Report & Quote

We are pleased to provide you with the following Report and Quote for the repair of your Gearbox model D123-789 s/n 555 with a 25.59:1 ratio as follows:

Failure Analysis Report

Failure Analysis Photo Report

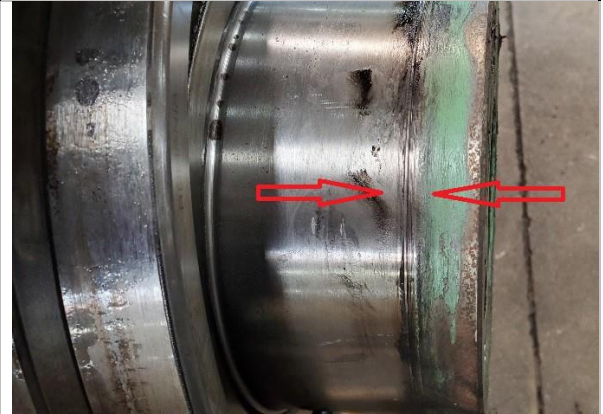
Low speed seal area have excessive wear.
 We recommend weld and repair of the low speed seal area to restore correct housing size.

Low speed and high speed gear sets show very little wear.
 We recommend clean and reuse.

High speed seal area have excessive wear.
 We recommend weld and repair seal area to restore correct shaft size.

All bore dimensions were measured and found to be within correct size tolerance. The housing shows minimal wear and may be reused with minor repairs.
 We recommend powerblasting to clean case, repair of (20) threaded holes and enamel painting of interior to prevent rust.
